Please read: Supplemental Instructions 90-6275

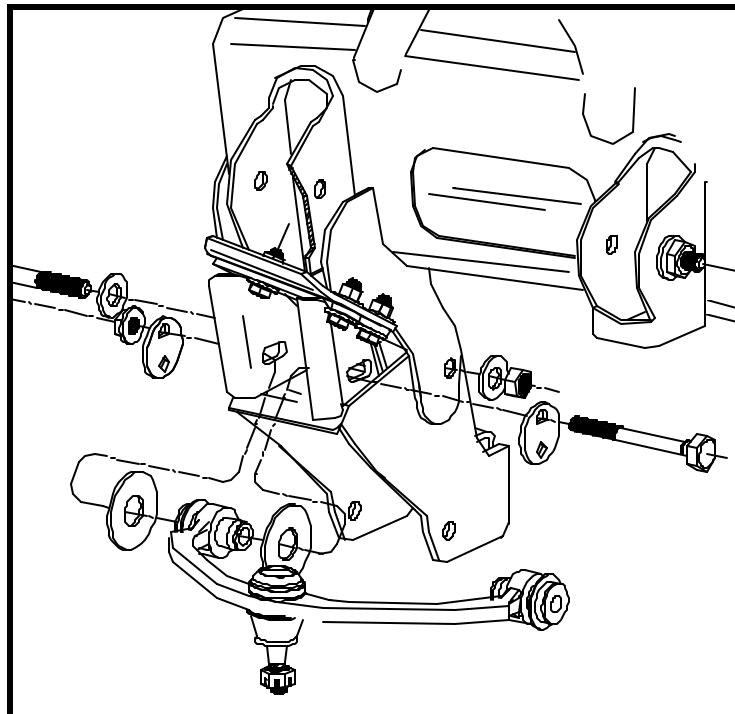
Due to manufacturing variances in the rear cross member, 90-1459, the rear upper arm may need to be shimmed into the pockets they sit in. This kit 90-6275 contains 8 shims that may be used for the installation.

If the rear of the upper arm has space when it is fit into the rear cross member you may add these shims where needed to take up this space. See the illustration provided. It is possible you may use all of the shims or none at all. Once the shims are installed you can install the bolt that will hold the upper a-arm and the shims in position and continue with the normal installation procedures.
